Subject: MHI's Response to US-APWR DCD RAI No. 591-4722 REVISION 0

Response to Request for Additional Information
No. 591-4722 Revision 0

RAI NO.: NO. 591-4722 REVISION 0
SRP SECTION: 09.03.03 – Equipment and Floor Drainage System
APPLICATION SECTION: DCD TIER 2 SECTION 9.3.3
DATE OF RAI ISSUE: 6/8/2010

Figure 1 ESF Room Drain Pipe with Piping Support Detail

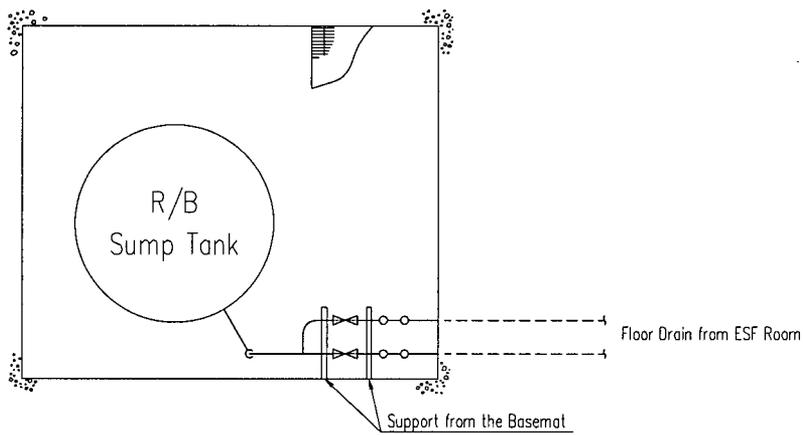
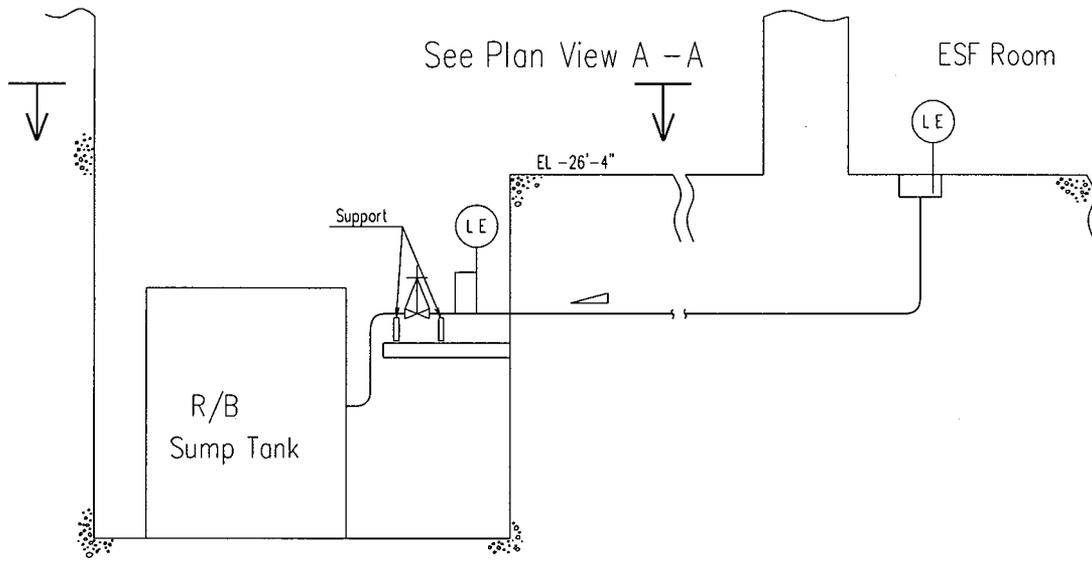
In order to demonstrate compliance with GDC 4, the applicant must demonstrate the capability to withstand the effects of and to be compatible with the environmental conditions (flooding) of normal operation, maintenance, testing, and postulated accidents.

Initially, RAI 299-2036, question 9.3.3-4 was submitted to request additional details on isolation signals, instrumentation and inadvertent operation of the isolation valves. Upon review of the response to question 9.3.3-4, the staff submitted a supplementary RAI 426-3167, question 9.3.3-15 stating that all references to safety-related isolation valves should be clearly distinguished from non-safety related valves in the DCD Section 9.3.3 and Figure 9.3.3-1. In the response to question 9.3.3-15 (Open Item 01), the applicant proposed to include the equipment class break on Figure 9.3.3-1 to clearly define the isolation valves for the safeguard component areas as safety-related and MHI has updated Revision 2 of the DCD accordingly. Although the isolation valves (identified as EC3) are properly classified as safety-related on Figure 9.3.3-1, the staff is unable to determine whether the piping from these safety-related valves into the safeguard component area are similarly defined as safety-related.

Therefore, the applicant is asked to provide the classification for the piping in question or define any potential failure scenarios that could impact the room as a result of failure of the non-safety piping portions and update the DCD as necessary.

A portion of the drainage piping from the safeguard components areas is embedded into the basemat. The portion of piping beyond the basemat, up to and including the safety-related valves [i.e. the isolation valves (FDS-VLV-001A/B/C/D)] is fully supported and restrained to minimize the potential for breaking (please refer to the attached Figure 1 for design details). Hence the piping is non-safety and is class 6. Only the drain isolation valves (FDS-VLV-001A/B/C/D) are safety-related and Equipment Class 3.

Figure 11.2-1 Liquid Waste Processing System Process Flow Diagram (Sheet 1 of 3)

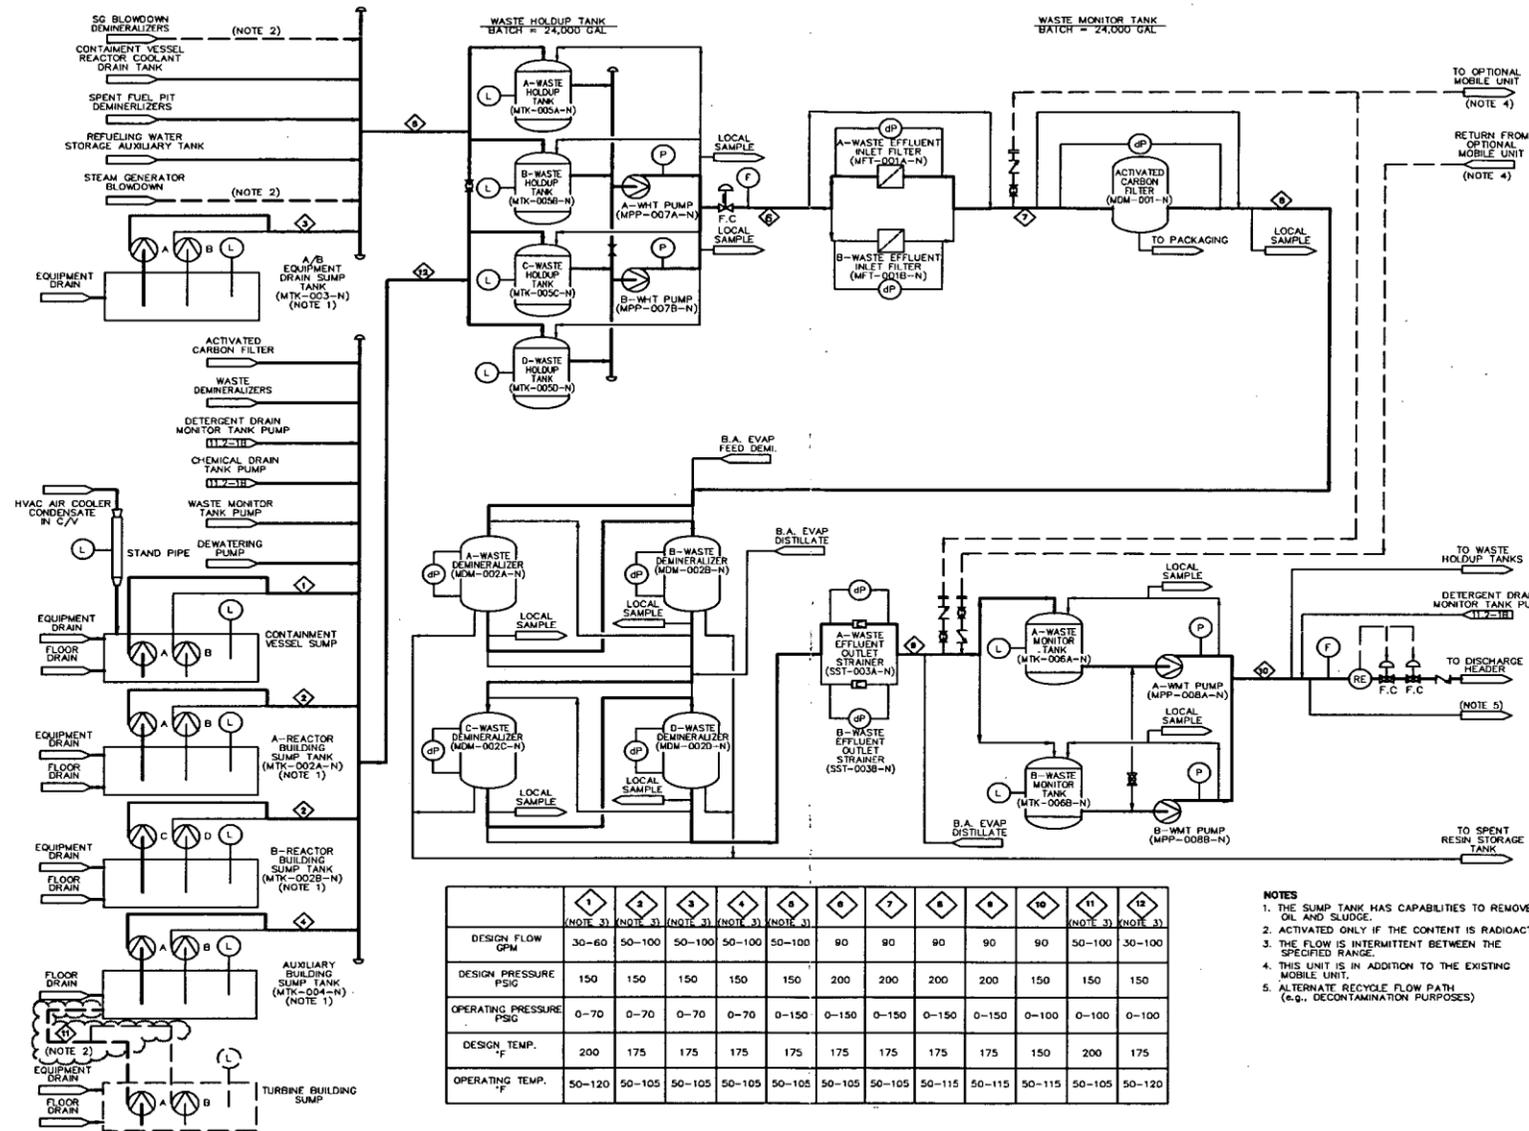
- 1) The proposed piping routing configuration in Figure 9.3.3-1 shows the T/B sump discharging into the A/B sump in Figure 9.3.3-1 and Section 9.3.3. However, this change is not properly reflected into Figure 11.2-1, which shows the T/B sump discharging directly into the waste holdup tanks. This results in an inconsistency between the figures.

- 1) Figure 11.2-1 will be revised as shown to illustrate that, when contaminated, the T/B sump is transferred to the A/B sump.

- 1) Figure 11.2-1 will be revised as shown in the attached figure.
- 2) No impact on DCD
- 3) DCD Section 9.3.3.2.2 (6.) will be revised to say:
